PLANNING DEPARTMENT STAFF ANALYSIS PLATTING

CASE: S12519

Lewis and Clark Subdivision, Lots 1 – 19 and Tracts A and B, and a 60-month phasing plan with a variance from AMC 21.07.060D.3.b.ii., *Internal Street Connectivity*

Lewis & Clark
 Subdivision
 Lots 1-19,
 Tracts A & B

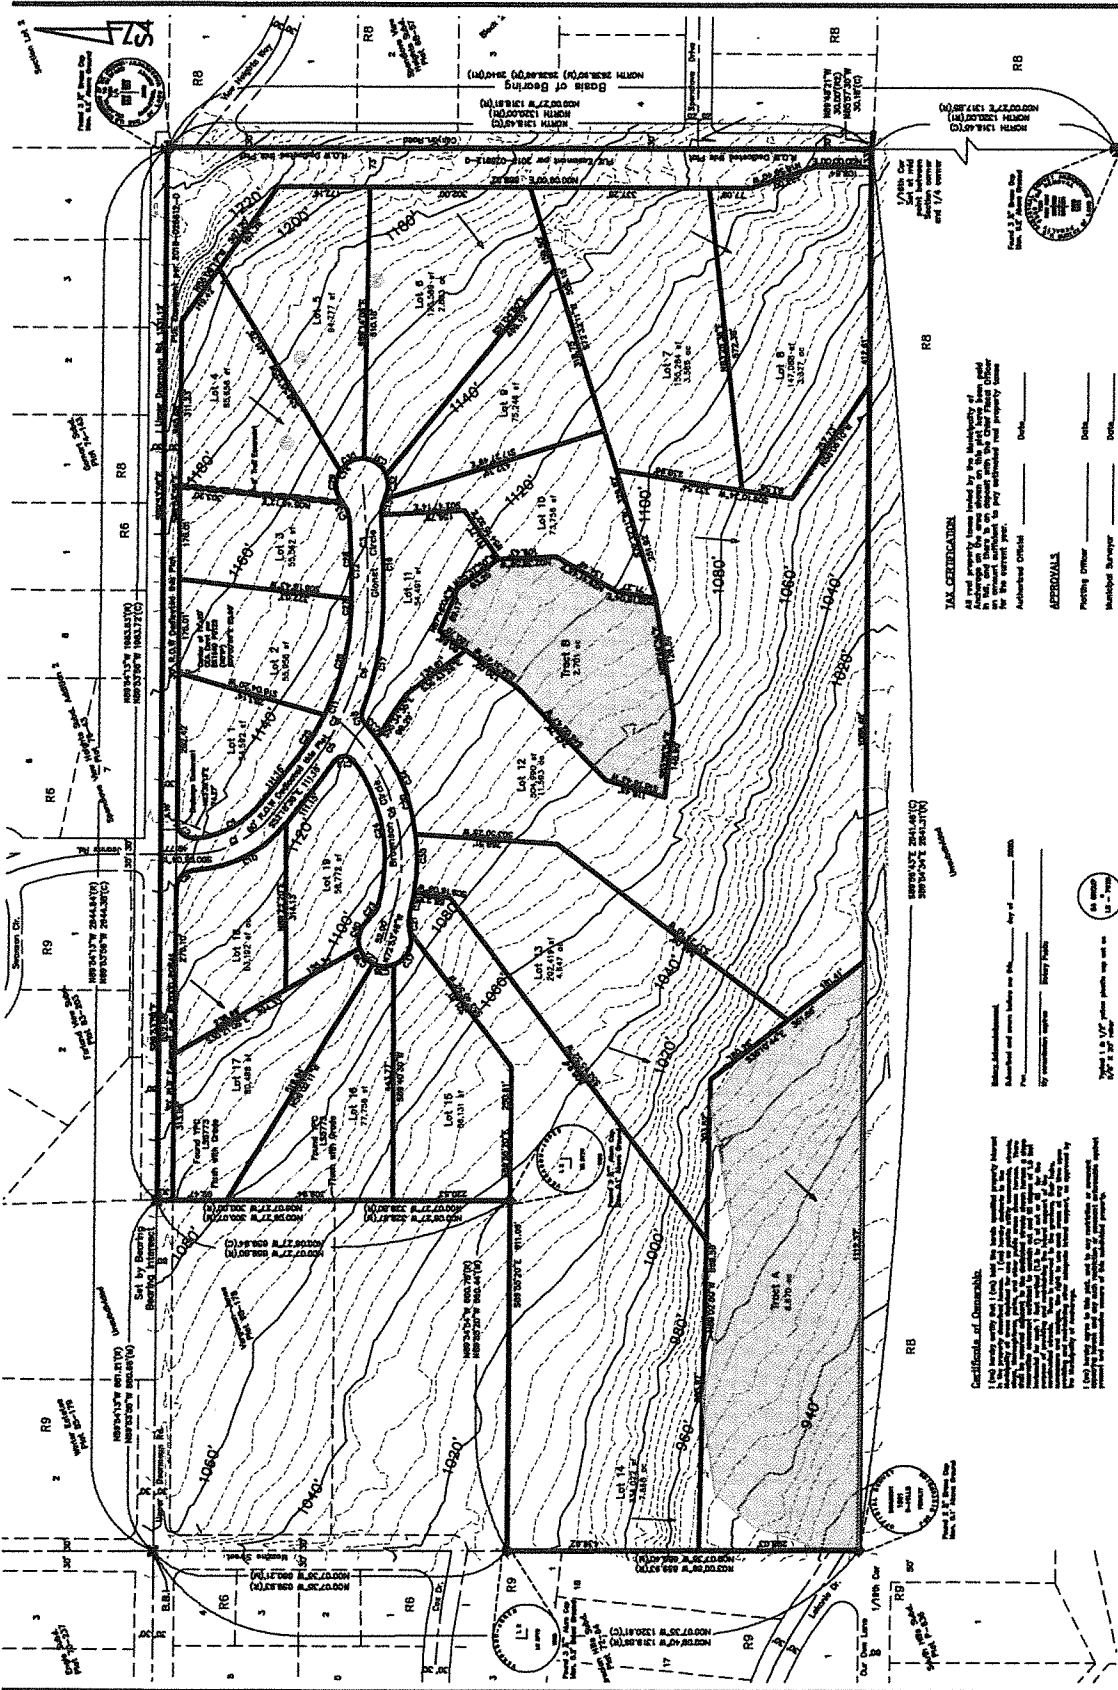
- a. The proposed plat does not match the MOA Hydrography GIS Layer. Resolve with WMS an accurate depiction of all waterbodies. Show the stream along the southern property line that is within 50.0 feet of the property line. Provide appropriate stream related plat notes.

- b. Show all drainageways with drainage easements on the plat. The drainageways may be relocated with approval from Private Development. It is possible some drainageways or ephemeral channels may be under the jurisdiction of the ACOE. If applicable obtain necessary permits.

- c. There is drainage coming onto this subdivision from Upper De Armoun Road. The drainage enters the subdivision on Lot 1 and goes to the proposed Gionet Circle ROW. Where does this drainage exit the ROW? The proposed ROW will also have drainage. Provide easements to an appropriate outfall for the drainage. There is a culvert under Canyon Road that appears to go to Lot 8. Provide an easement for this drainage.

- d. Tracts A and B are shown with a green stipple pattern. Please show on the plat what this represents. If it is wetlands, resolve with the Planning Department if additional wetland related plat notes are required.

- 4. Show the location of the stream as well as the off-property stream near the south lot boundary.
 - 5. Resolve with Private Development, the need for drainage easements.

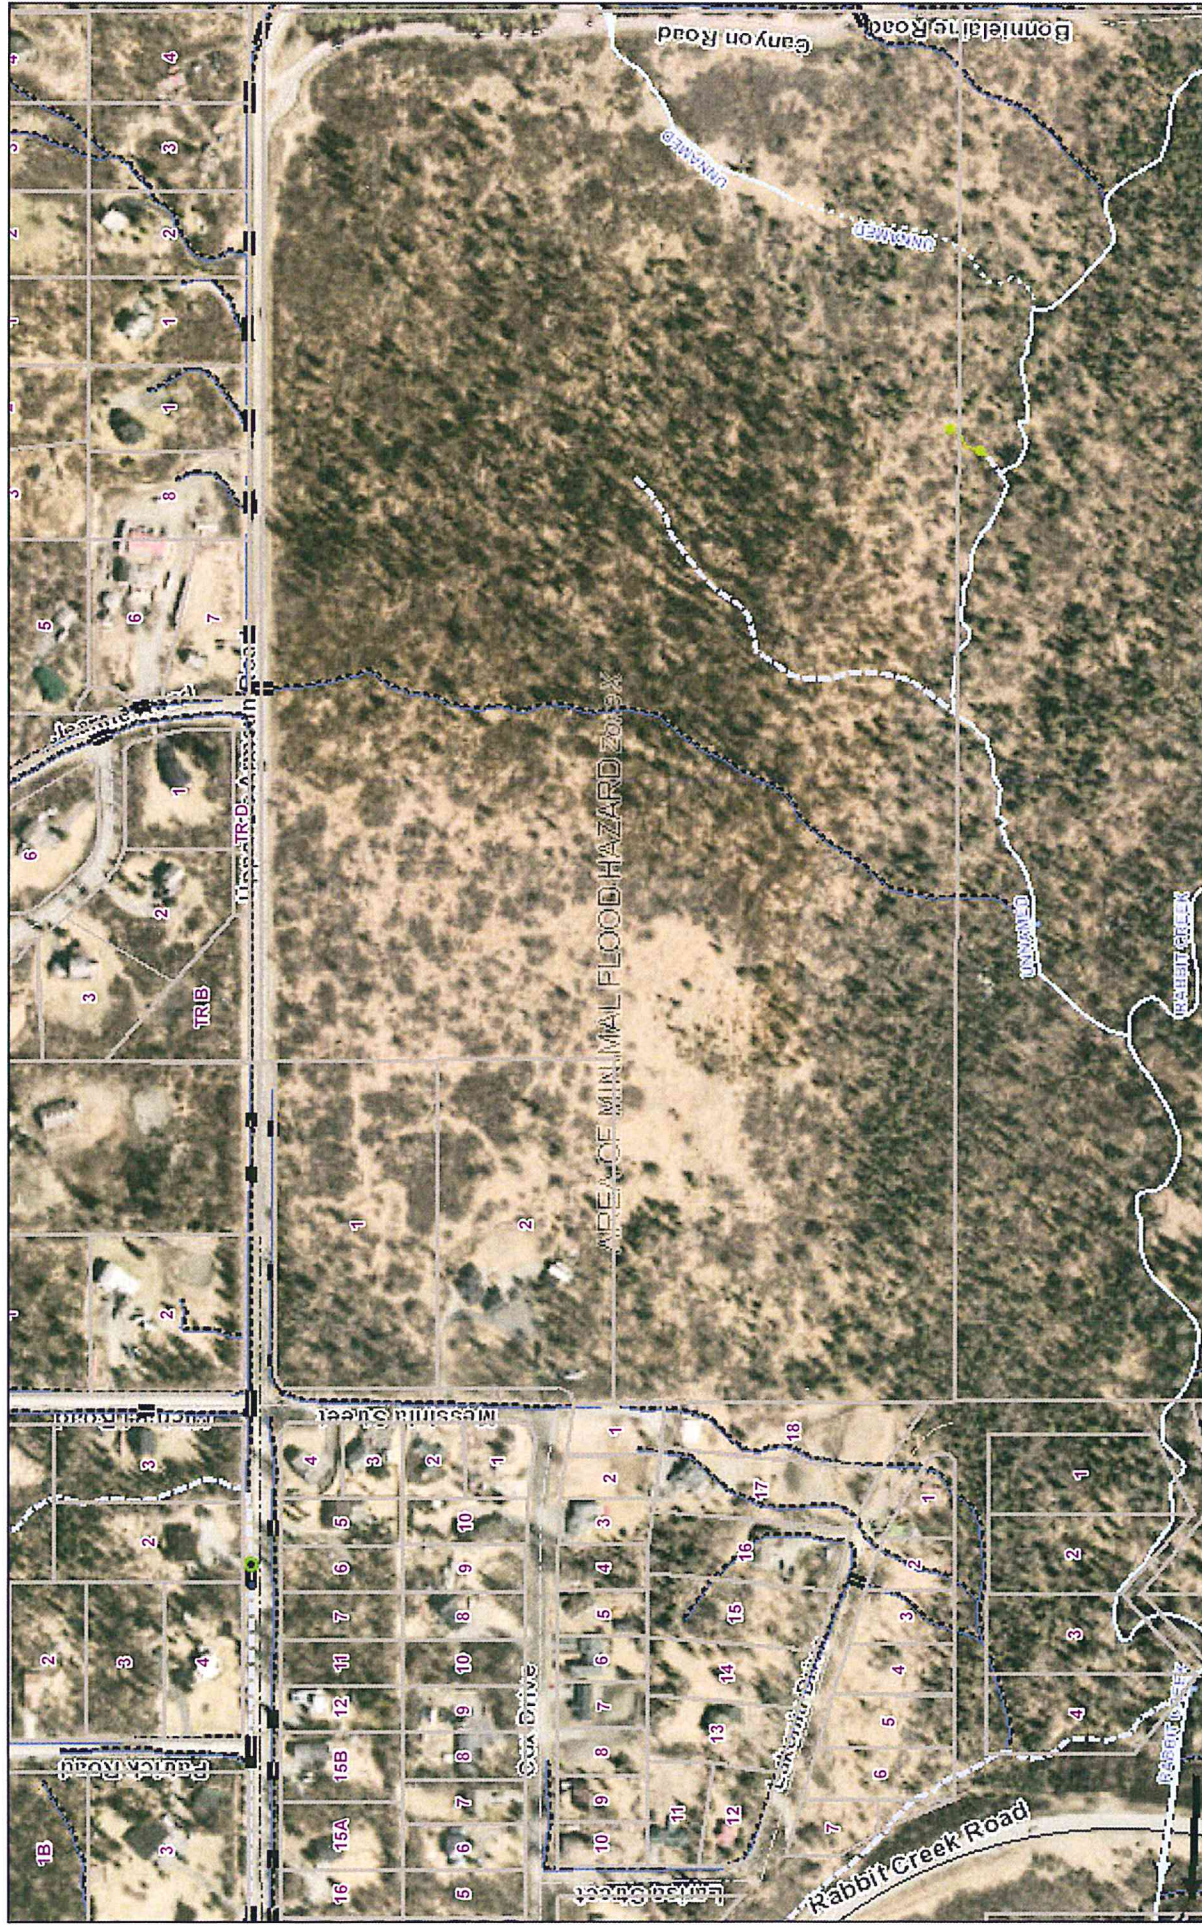
S12519, Lewis and Clark Subdivision. WMS requests the following conditions.
The proposed plat does not match the MOA Hydrography GIS Layer. Resolve with WMS an accurate depiction of all waterbodies. Show the stream along the southern property line that is within 50.0 feet of the property line. Provide appropriate stream related plat notes.

Show all drainageways with drainage easements on the plat. The drainageways may be relocated with approval from Private Development. It is possible some drainageways or ephemeral channels may be under the jurisdiction of the ACOE. If applicable obtain necessary permits.

There is drainage coming onto this subdivision from Upper De Armoun Road. The drainage enters the subdivision on Lot 1 and goes to the proposed Gionet Circle ROW. Where does this drainage exit the ROW? The proposed ROW will also have drainage. Provide easements to an appropriate outfall for the drainage. There is a culvert under Canyon Road that appears to go to Lot 8. Provide an easement for this drainage.
